**Record of Decision
Photocircuits Corporation
Operable Unit No. 1
City of Glen Cove, Nassau County, New York
Site Number 130009**

March 2008

DECLARATION STATEMENT - RECORD OF DECISION

Figure 3 - RI Groundwater Sampling

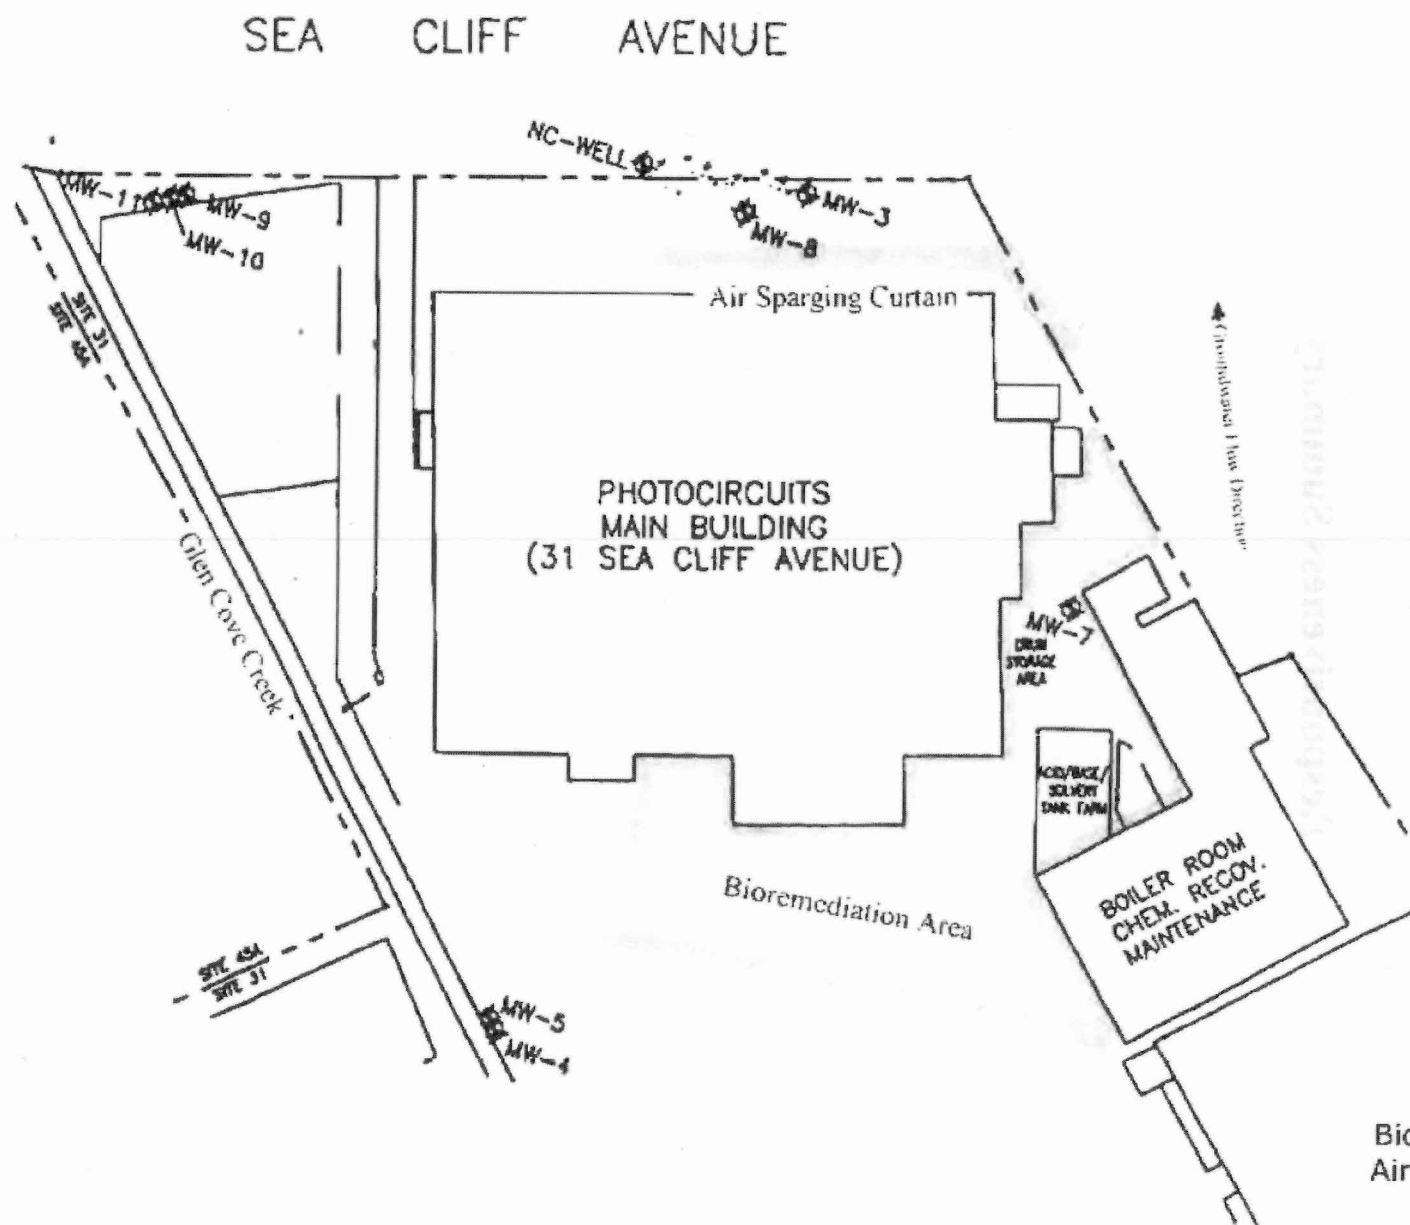
COMMENT 34: Comment 5: P. 4, Para 2, Line 2: A comparison of Figures 2 and 3 indicate that much of the Photocircuits property, including the entire area near Butler 2 was never investigated. This would result from the fact that only a Focused Remedial Investigation was performed. The NYSDEC should include data for other areas of the site, if any exist. If no additional data exist, additional investigation - including sampling within the building footprint underlying

RESPONSE 34: Investigations performed prior to the FRI include the "Source Area Investigation for the Sea Cliff Industrial Area" performed in 1992, and the "Preliminary Site Investigation" performed in 1996, both cited in the PRAP. These reports identified the drum storage and tank farm areas located to the east of the Photocircuits' main building as the primary areas of concern at the site. Inclusion of the data from these investigations is beyond the scope of a PRAP, however, both documents are available in the repositories.
